CITY OF RICHLAND DEVELOPMENT SERVICES DIVISION
STAFF REPORT TO THE HEARING EXAMINER

Proposal Name:	Peach Tree Estates III Preliminary Plat
Location:	1251 Bermuda Road
Applicant:	Jason Mattox of PBS Engineering & Environmental
Property Owner:	MD&D Investments LLC
File #:	PLN-T3-2025-00004 & PLN-T1-2025-00282
Description:	Request to divide three (3) parcels totaling approximately 58.39 acres into 242 new residential lots and four (4) commercial tracts.
Project Type:	Type III Preliminary Plat Approval
Hearing Date:	September 8, 2025
Report By:	Ryan Nelson, Planner
Recommended Action:	Approval subject to completion of proposed conditions.

SHEET 1 OF 5

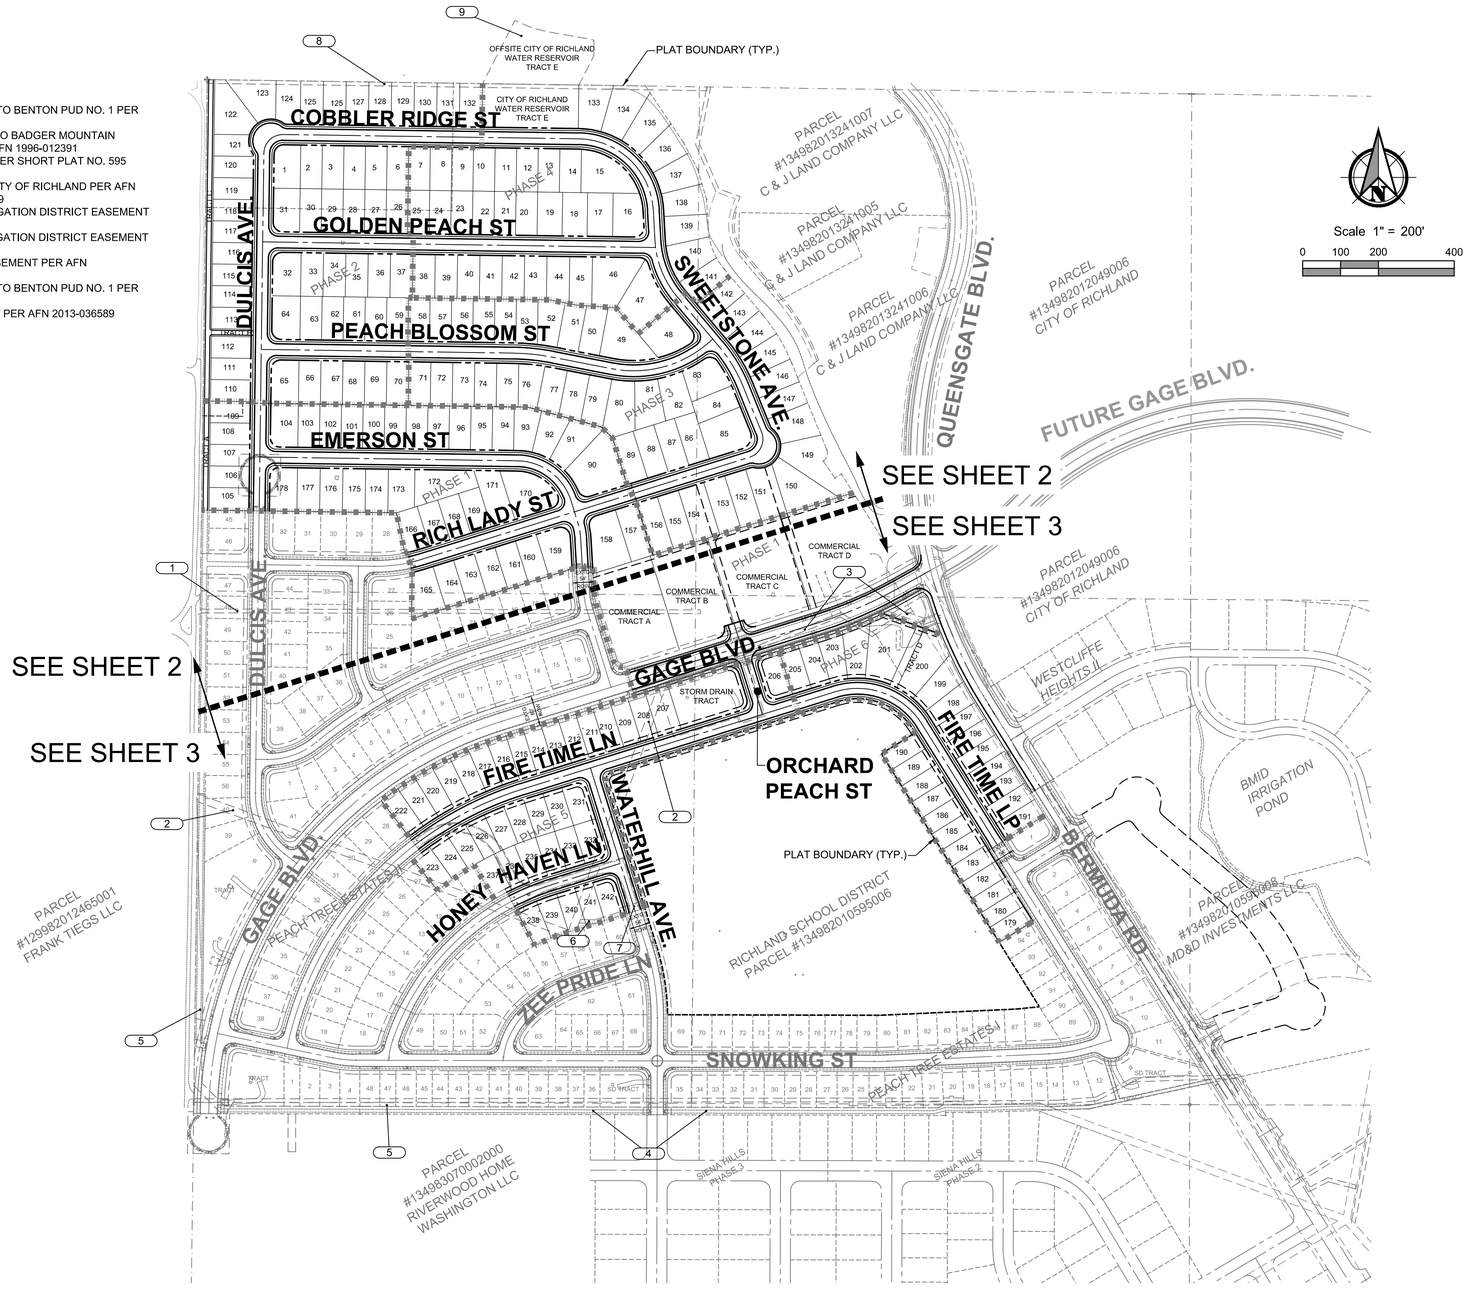
2. On Sheet 1 and Sheet 4, there are two Lot 125s along the northern portion of the plat, please revise and re-label the lots appropriately.

DESIGNED:	ELG/MCR
CHECKED:	JLM
	JUNE 2025
	24012988
SHEET ID	
SHEET	3 OF 5

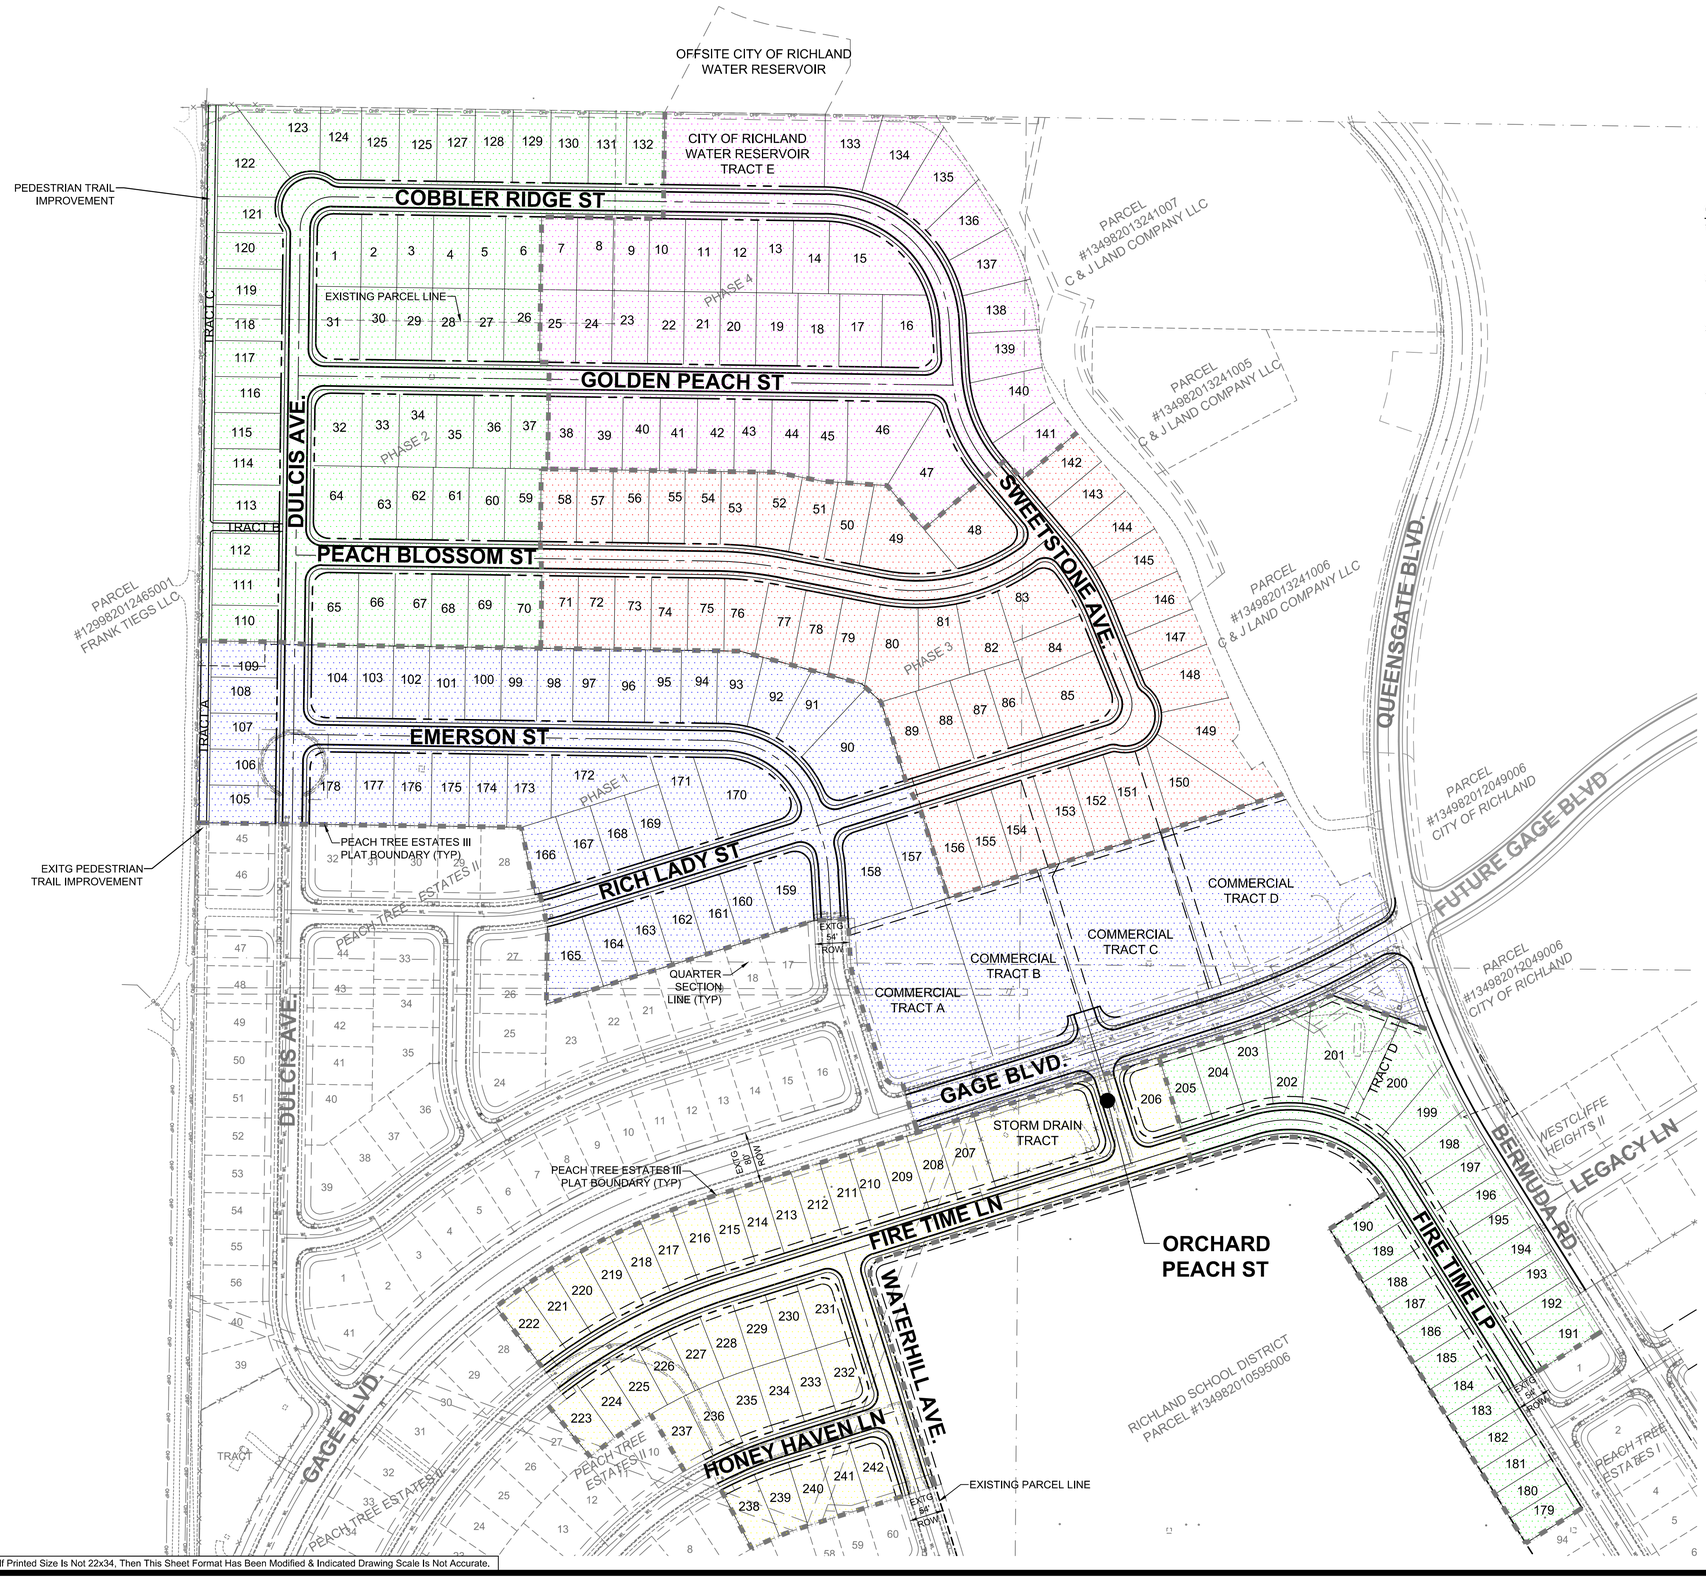
B. Open spaces
    - Open spaces have been designated on this preliminary plat, as Tracts A, B, and C. Tract D was not identified as being open space or pedestrian access, but is shown on Sheet 3 of the proposed plat.
